**Malibu Creek Ecosystem Restoration Study**  
**Los Angeles and Ventura Counties, California**

**Appendix S**  
**Response to Comments**

**U.S. Army Corps of Engineers**  
**Los Angeles District**

## RESPONSES TO PUBLIC AND AGENCY COMMENTS

Figure 3.3-1 Geologic Map of Dam and Impound

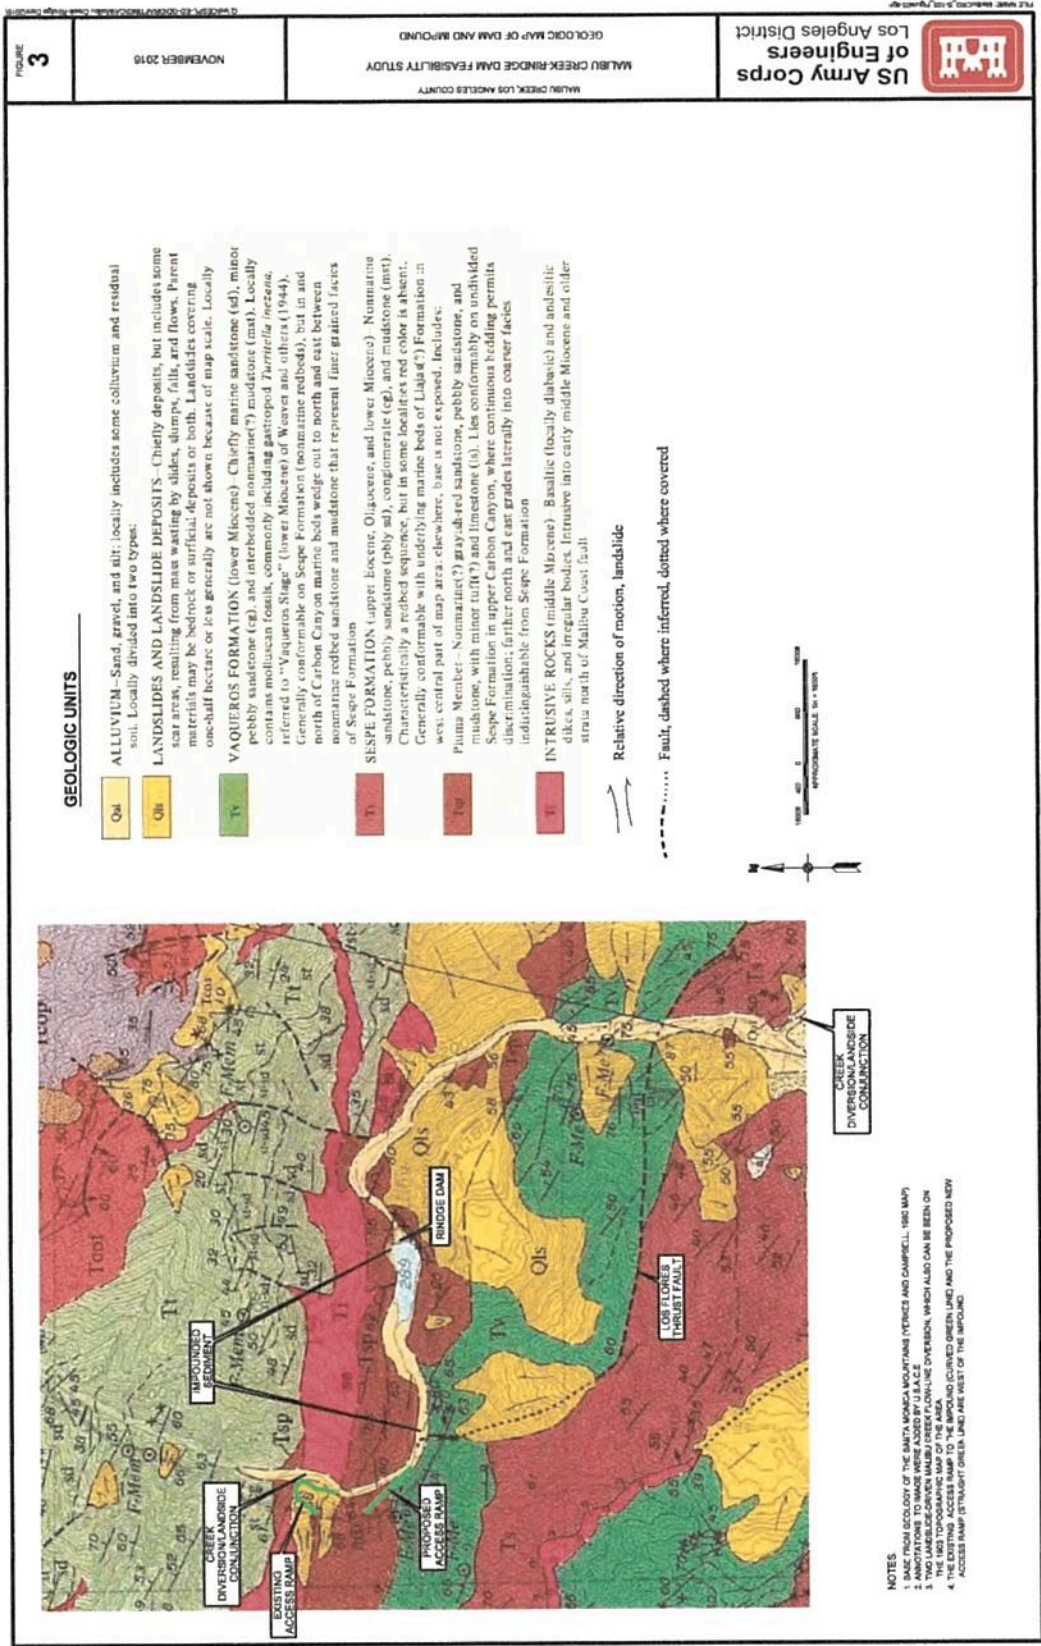
The landslide is approximately 1,900 feet long and up to 1,000 feet wide and 500 feet high and rivals the size the infamous Big Rock Mesa Landslide. The landslide is shown relative to Malibu Canyon Road and the Rindge Dam on the attached Figure 3.3-1 Geologic Map of Dam and Impound, and on the attached Local Geologic Map by Dibblee (1993).
